Chatham Ridge Subdivision Phase II Preliminary Plan

Portland, Connecticut

Environmental Review Team Report

Report #591

Vernal pool egg masses

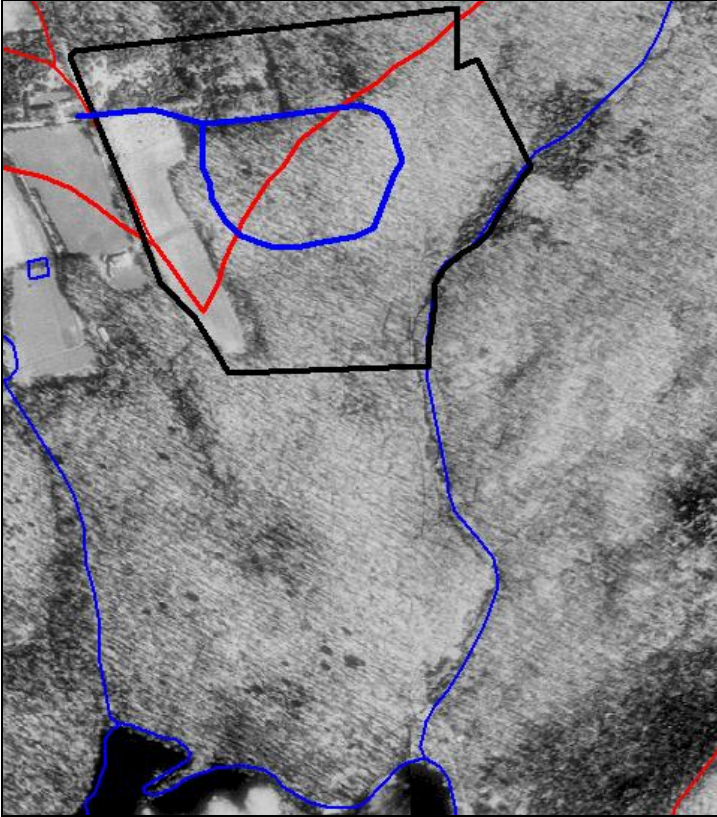
The plans do not show much impact on the on-site wetlands. The dominant wetland features are the intermittent watercourse to the southeast and Rattlesnake Brook to the east. Rattlesnake Brook after leaving the vicinity of the site flows about 2,100 feet into Great Hill Pond. A vernal pool was located along the logging road behind proposed lots 16/17.

This 1990 aerial photograph shows the approximate parcel boundaries, water courses, proposed road way, and drainage divide.

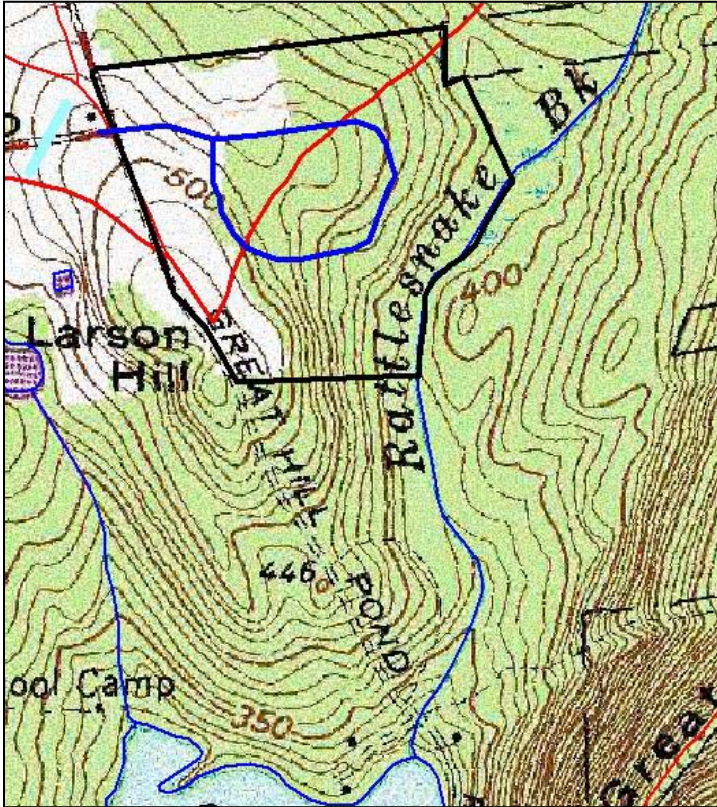
There is cause of concern as to the overall change in surface drainage. As can be seen on the topographic map and the aerial photograph below, the drainage divide crosses the parcel on a diagonal from the northeast to the southwest. This divides the parcel approximately 42% to the northwest and 58% to the southeast. The northeast section will drain generally north into the Stocking Brook drainage and southeast of the line will drain to Rattlesnake Brook. These percentages have been, for the most part, maintained in the system of catch basins and storm drains. On average, there are no structures within 300 to 500 feet of the Brook.
